Item ID: D4634-141 Accept ***N900040100*** Setup Start ***NS1***
Revision ID: Stop ***NS2***
Item Name: Fwd, Center Ceiling Replacement Panel Assembly
Start Date: 7/13/2016 Start Qty: 1.00 ***1*** Cust Item ID:
Required Date: 7/19/2016 Req'd Qty: 1.00 ***1*** Customer:
Reference:

Work Order: 149139		DISPOSITION		AGAINST DEPARTMENT/PROCESS					
Part No. D4634-141		Rework ☐		Skid-tube ☐	Cross tube ☐	Water Jet ☐	Engineering ☐		
NCR No. 16-5994		Scrap ☐		Machining ☐	Small Fab ☒	Prod. Eng. Coord. ☐	Quality ☐		
		Use-as-is ☐		Thermoforming ☐	Finishing ☐	Rec/Store/Packaging ☐	Other ☐		
		Suspected Unapproved ☐		Large Fab ☐	Composite ☐	Supplier ☐			
Date: 16-08-22		Step #: 110		QTY Effective: ①			MRB (QSI042) Approval		
Description Work Order Deviation				Disposition			Completed By		
WHILE INSTALLING MS20426AD 3-6 RIVETS THE RIVETS WOULD NOT INSTALL WITH OUT DAMAGING LEXAN MATERIAL CR 16-153				REMOVE MS20426AD 3-6 RIVETS AND INSTALL CCR26455-3-03 RIVETS (M135127) (4) QTY see attach Email.			AUG 22 2016 DAS 27 9-89 16-08-22		
							Lead hand / Supervisor Approval Verification		
							QC / QA Coordinator Approval		
							DAS 9 9-89 16-08-22		
Root Cause				FAULT CATEGORY					
Environmen

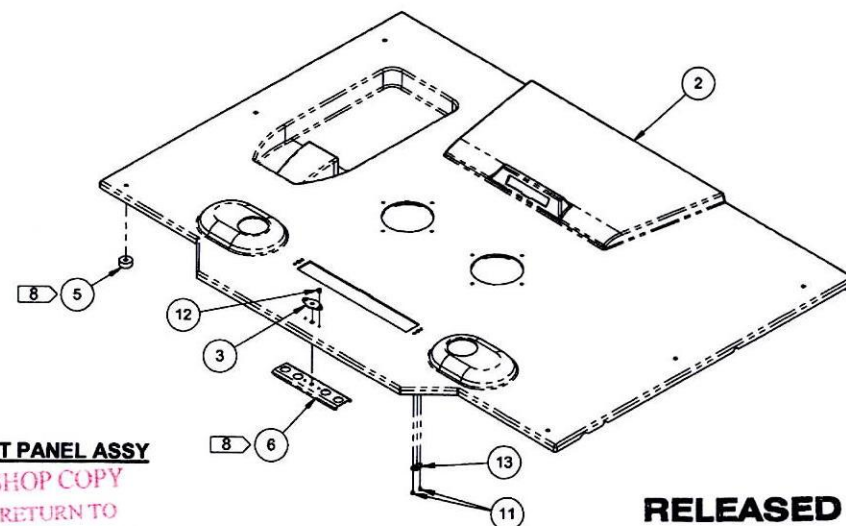
I saw the problems he was having and suggested to replace the rivets as a production tweek. I assessed the situation and suggested using an Anchor Nut Rivet (CCR264SS-3-03) when replacing the unacceptable rivet he showed me.

The installer took the initiative not to install the solid rivet in the remainder of the panels and complete the parts with CCR264SS-3-03 which turned out acceptable. (Picture 135324)

On the part which was brought to my concern there was superficial damage when he removed the rivet.

The fix would be to manufacture two small doublers (Picture:133104 and 133053) from 6061T6 0.020 Aluminum and dimple the top side, alodine, then sandwich the Lexan between the two doubles and bond in place, while attaching the Anchor Nut with CCR264SS-3-03.

- Is it for ease installation. Are we having issues with current ones?
- Have we tried on MS20426AA rivet?
- Would we rather go with "click bond"
- Have tried the "pop" rivets – do they crack the material at edge of the hole?
- What is the cost increase per panel using the "pop" rivet.

They are assembling D4634-14X Ceiling Panels on the floor. To mount the Light, we have two nutplates riveted to the ceiling panel using MS20426AD3-4 solid rivets (eg. Sheet 7, Item 10). They are installing these nutplates using a hand bucking tool and have asked if this could be changed to a countersunk POP rivet to simplify the assembly?

It is acceptable the modification your suggested adding doublers and CCR264SS-3-03 as an alternate to the MS20426AD3-6 rivet for the product is on production to fix the issue.

This can all be documented on the work orders as a NCR and a CAR would be generated to update the BOM to call out the CCR264SS-3-03 as an alternate to the MS20426AD3-6 rivet currently called out.
